**SUBJECT: DAVIS-BESSE NUCLEAR POWER STATION, UNIT 1 - STAFF ASSESSMENT
OF FLOODING FOCUSED EVALUATION (EPID NO. L-2019-JLD-0007)**

STAFF ASSESSMENT BY THE OFFICE OF NUCLEAR REACTOR REGULATION
RELATED TO THE FOCUSED EVALUATION FOR
DAVIS-BESSE NUCLEAR POWER STATION, UNIT 1
AS A RESULT OF THE REEVALUATED FLOODING HAZARD NEAR-TERM TASK FORCE
RECOMMENDATION 2.1 - FLOODING
EPID NO. L-2019-JLD-0007

Figure 3.2-1 Davis-Besse Site Layout (taken from licensee's February 25, 2015, FHRR)

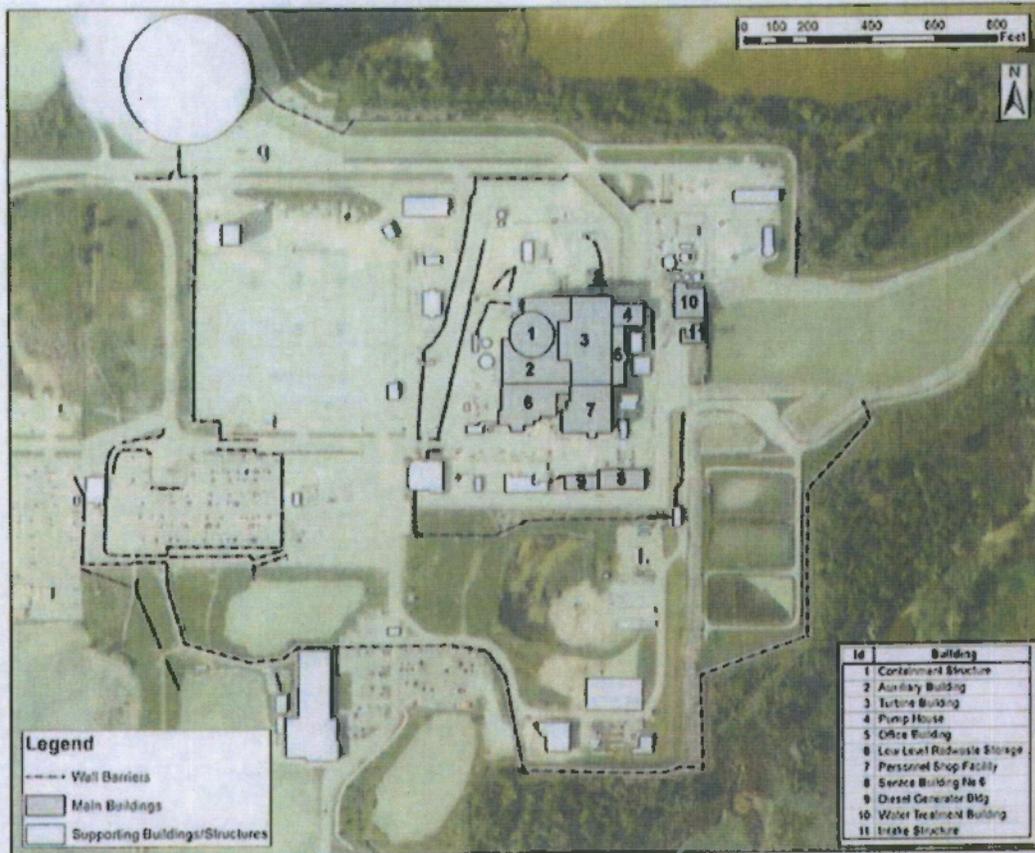
The ISR LIP evaluation generated a maximum ponding level of 585.5 ft, which exceeds the safety-related building entry point levels of 585 ft. Based on this potential for in-leakage, the staff reviewed the key SSCs in each potentially affected building. Figure 3.2-1 provides a site layout. The staff also considered the February 25, 2015, FHRR and ISR LIP flood elevations at key doors that are summarized in Table 3.2-1.
